Bullmoose Mine

2017 Dam Safety Inspection

Bullmoose Tailings Dam

Bullmoose Mine
Bullmoose Tailings Dam
2017 Dam Safety Inspection – Rev. 1

INSTRUMENTATION SECTION A

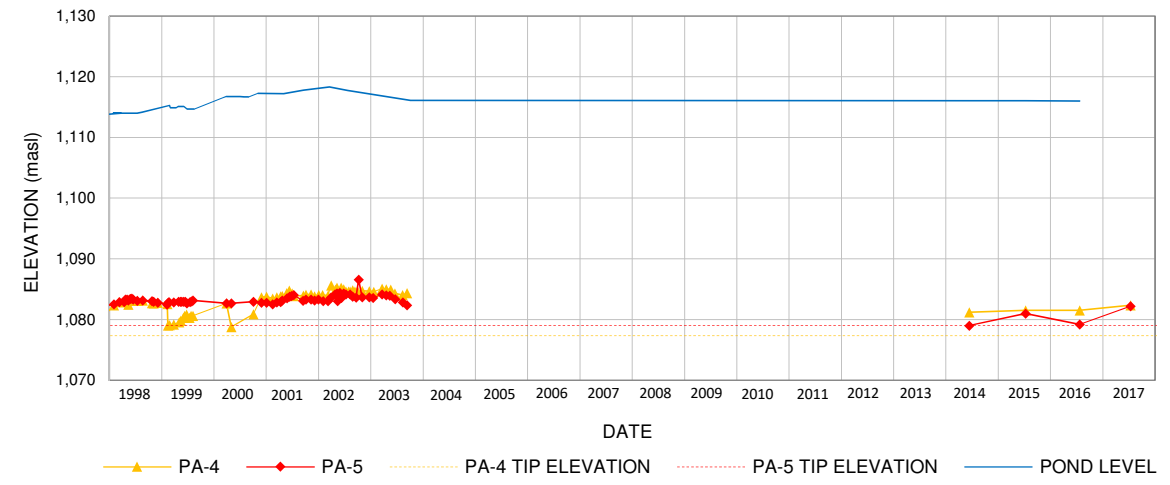
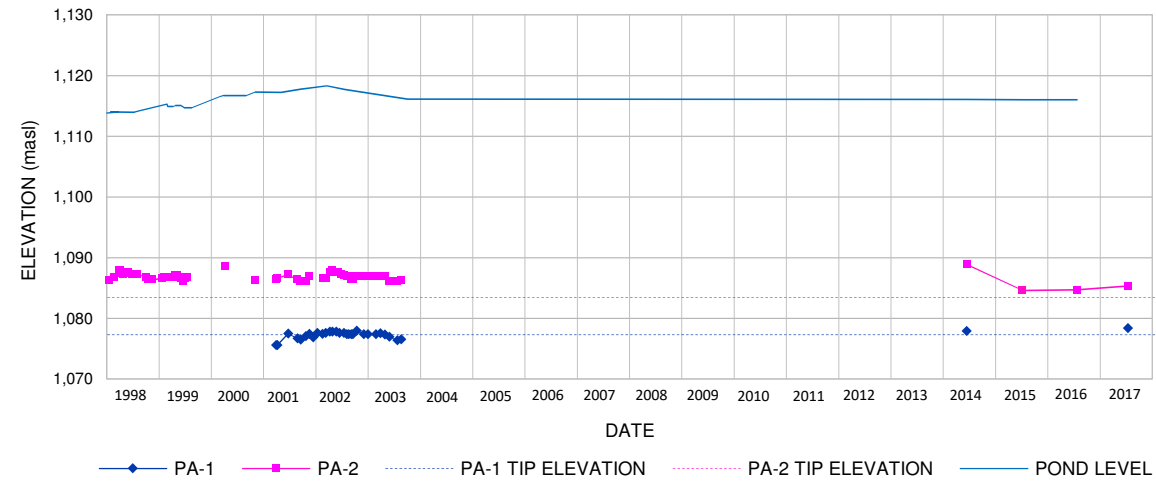
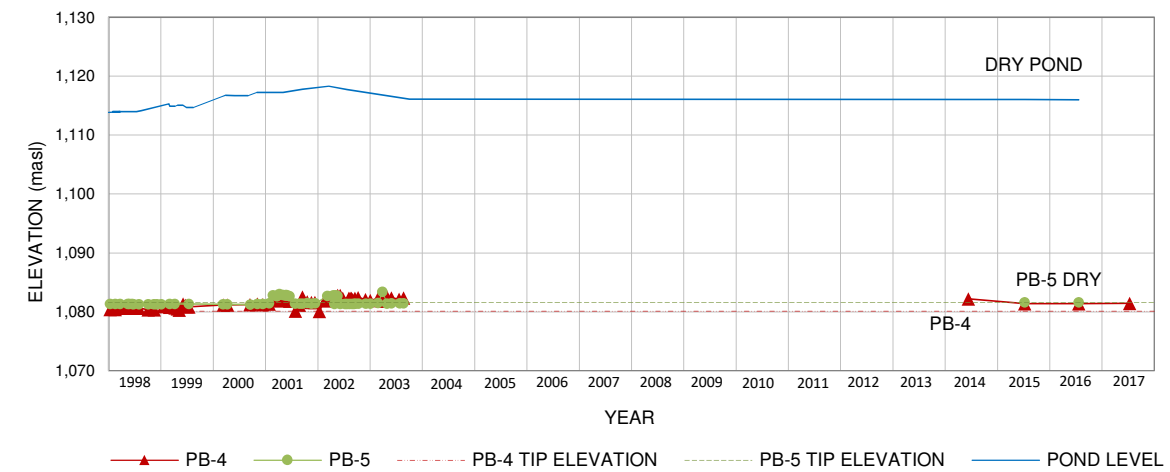
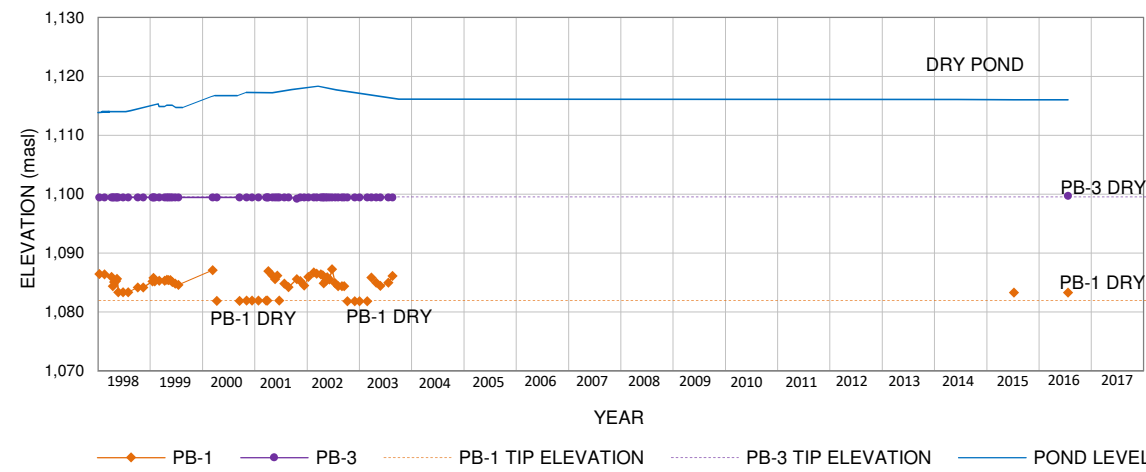
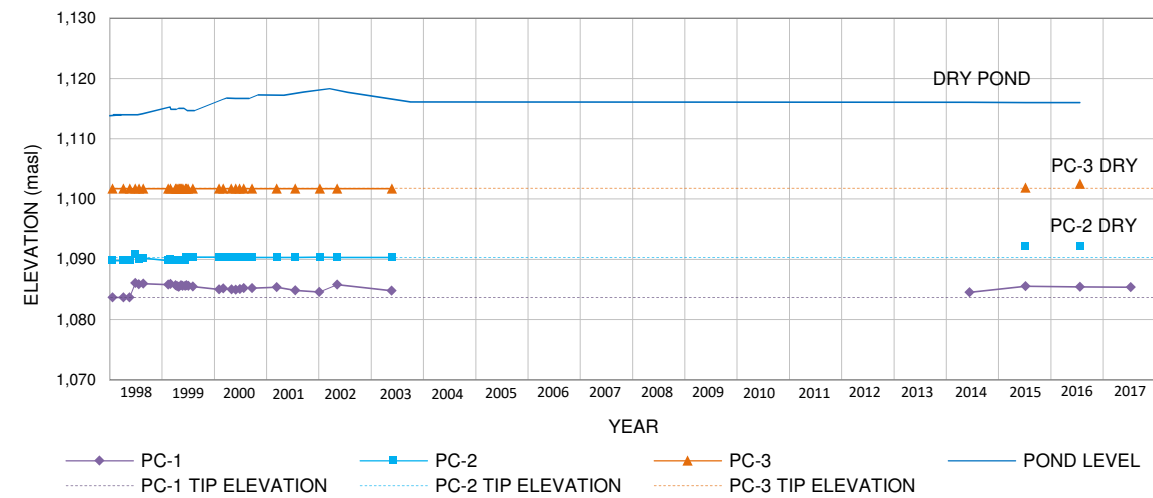
- 6 piezometers (PB-1, PB-3, PB-5, PC-2, PC-3 and MW-1/5) were “dry” (no water table measured within piezometer casing). Piezometers PB-4 located adjacent to PB-5 indicates water level slightly below PB-5 tip elevation (Figure 4).

Low pore pressures in the downstream shell of the dam indicate that dam drainage and foundation seepage capacity exceeds flow requirements (see Figure 4). Pore pressures have been stable and the dam shell is drained with low gradient of approximately 0.04 to 0.05 (KCB 2018b). Operation and construction induced pore pressure responses are no longer observed. Therefore, piezometers monitoring frequency of once per year is sufficient for ongoing monitoring of the structure under “Closure-Passive Care” conditions.

SECTION A
FIG. 1

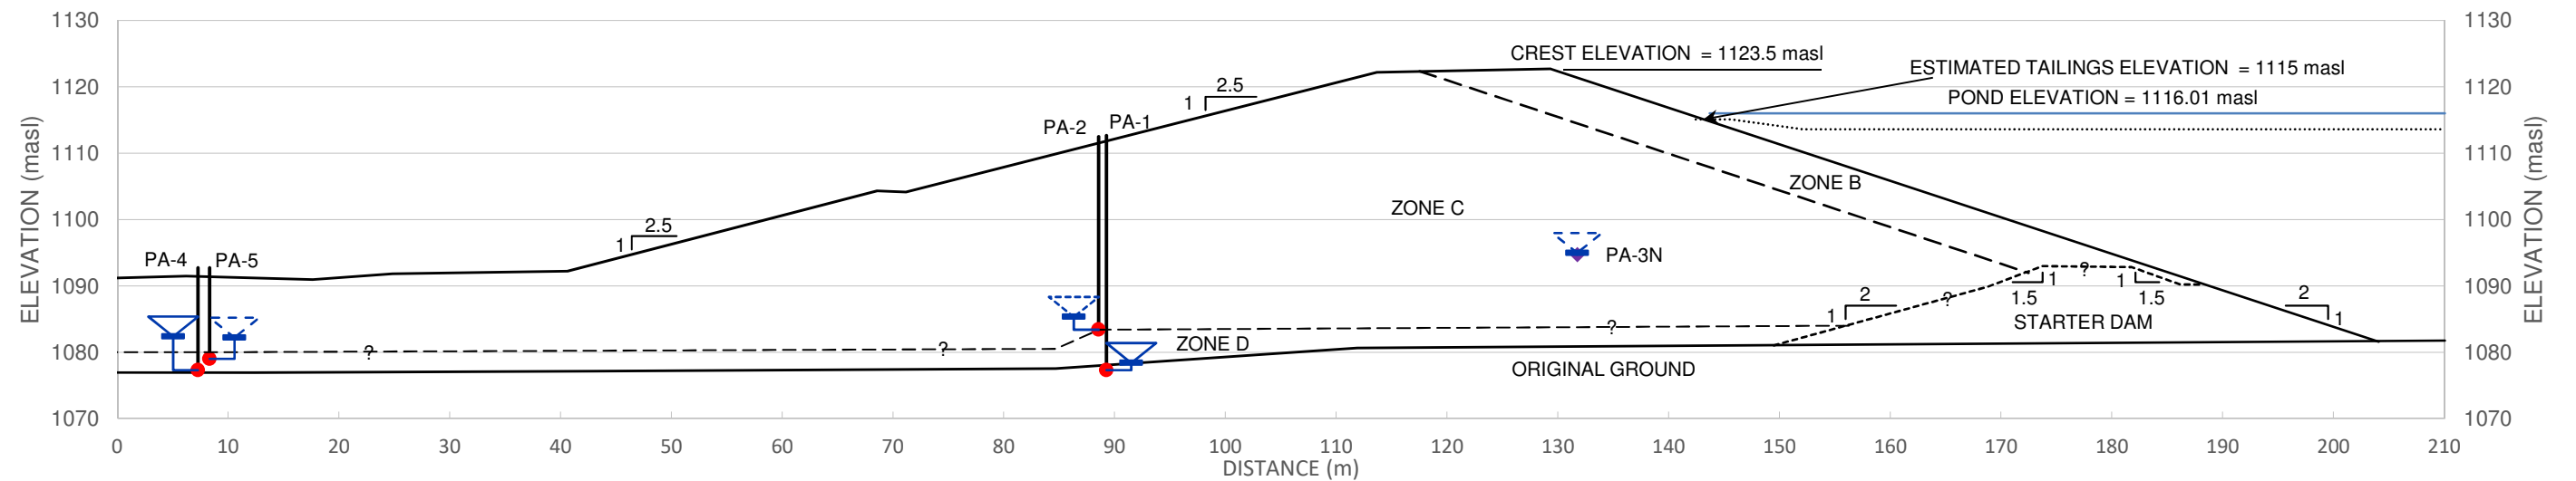
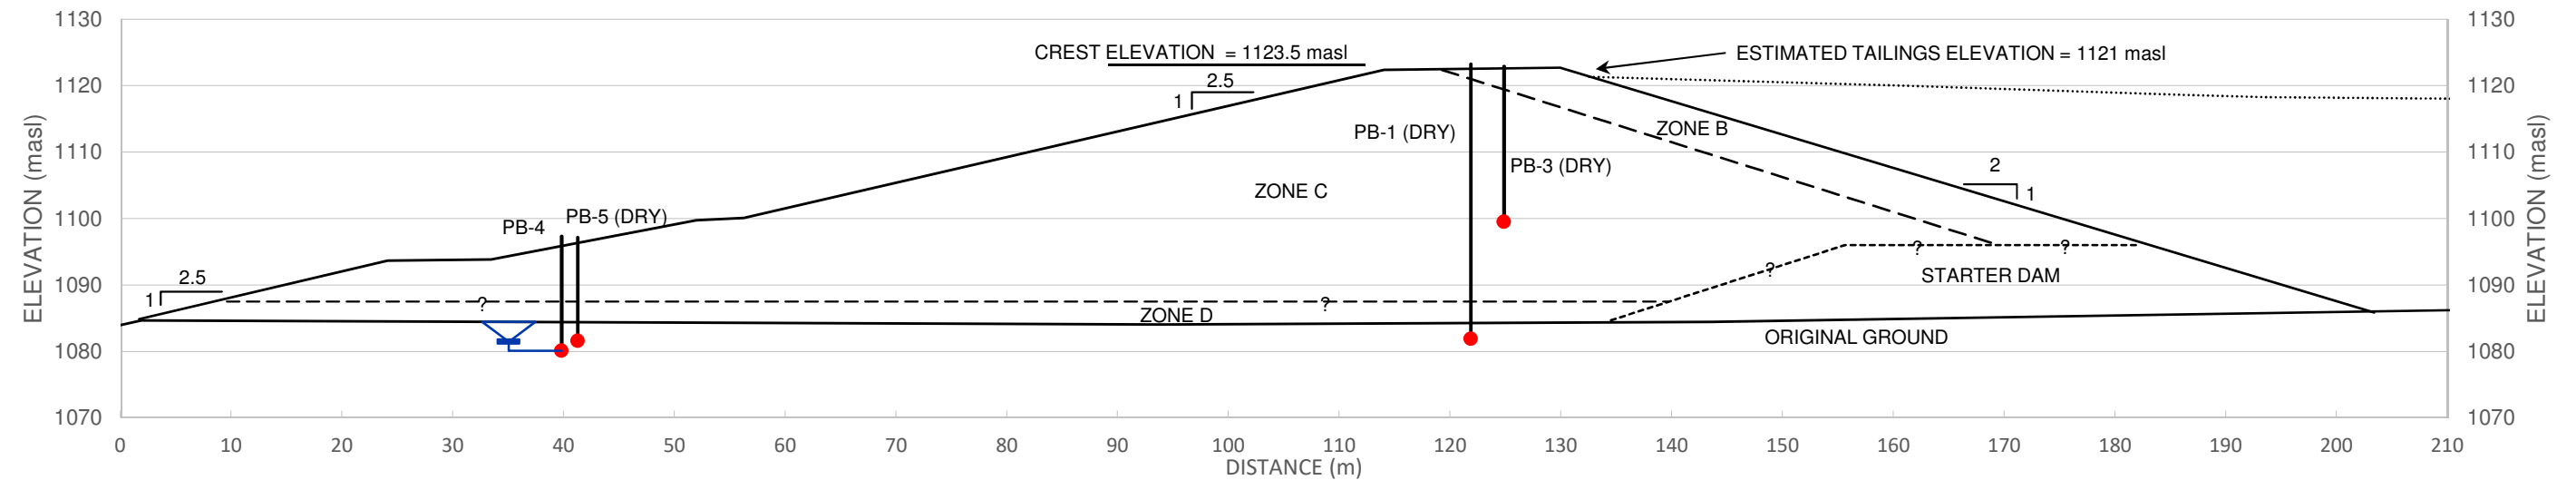
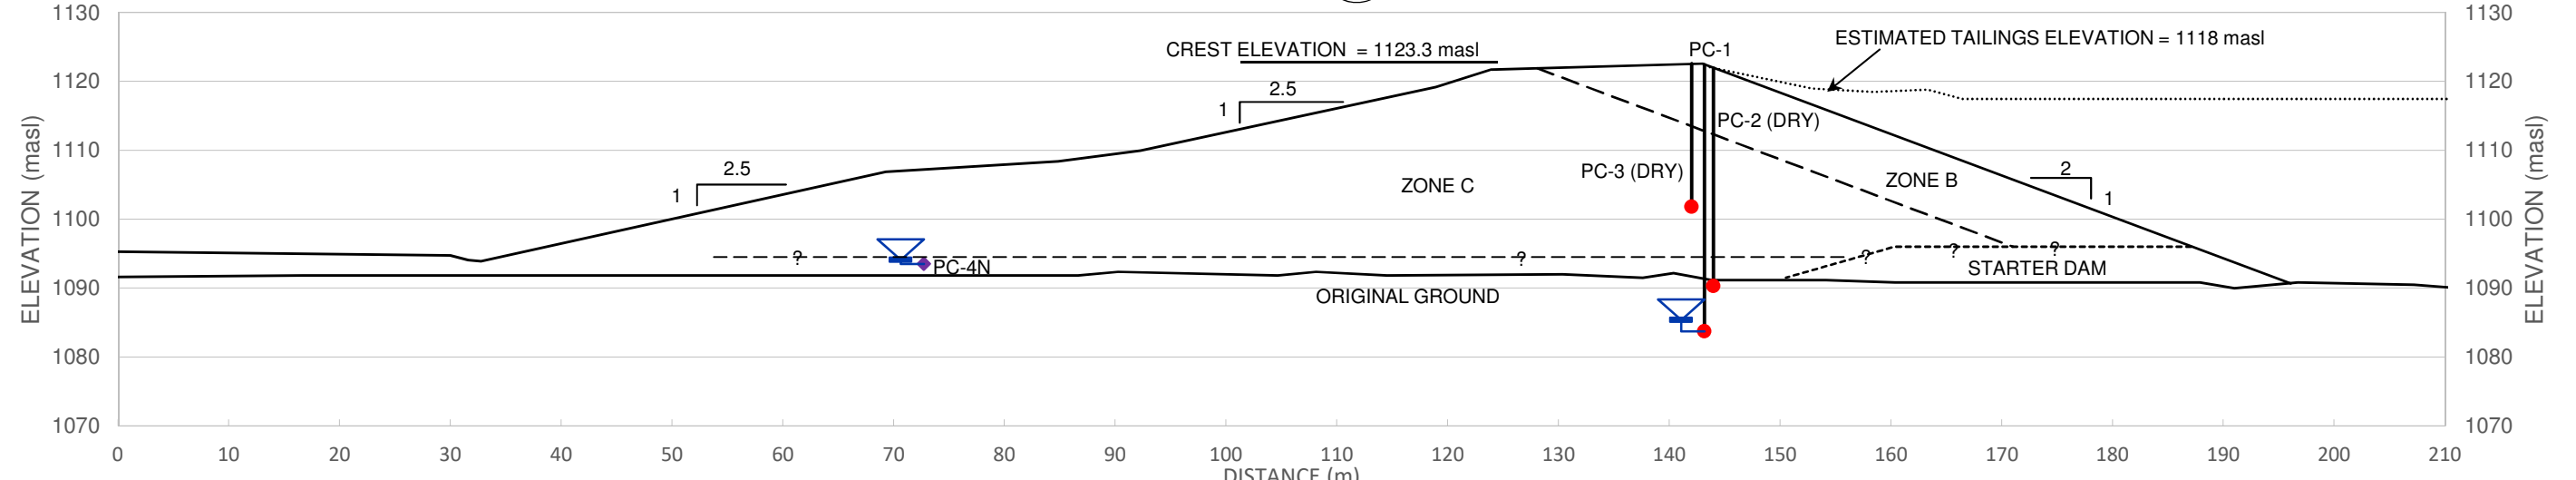
Figures 2 and Figure 3 summarize recent and historical piezometer readings. Figure 4 shows piezometric level across dam schematic Sections A to C.

- All measured piezometers have similar water levels to those measured in 2016 except PA-2, PA-4 and PA-5 (see Figure 3).
 - ◆ PA-2 water level has dropped about 4 m between 2014 and 2015; the instrument has been relatively stable since 2015 with a slight increase in 2017.

Photo II-32 Teck removed vegetation at the inlet and along the channel of spillway in October 2017 – looking northeast (near photograph location BTD-2017-21)

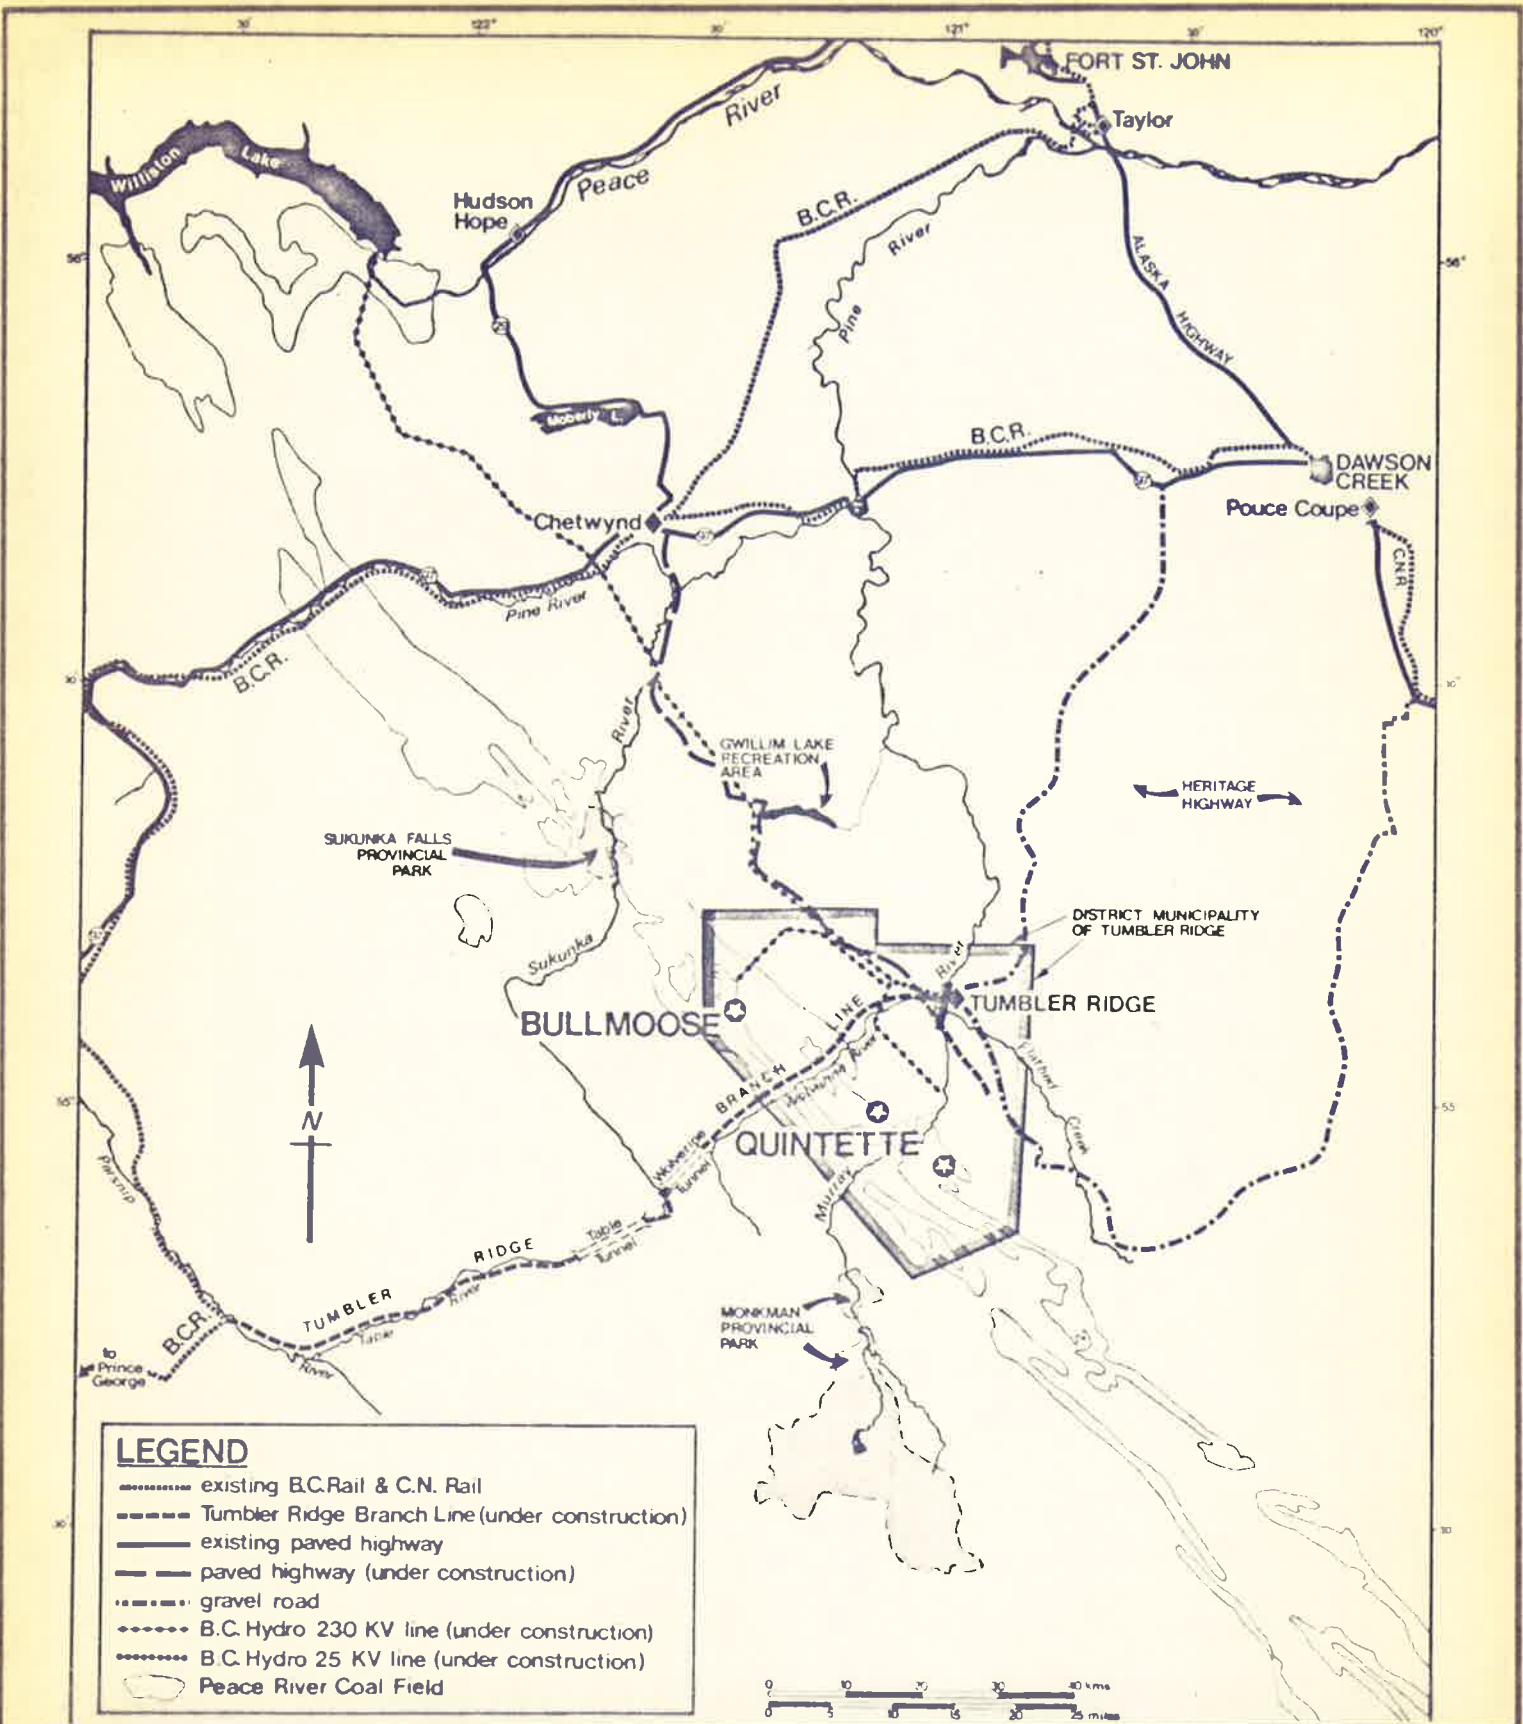
Photo II-31 Toe of the dam along west slope is approximately 1.5H:1V – possibly used as an end dump prior to closure. The slope appears to be stable with no significant sign of erosion or movement (BTD-2017-25)
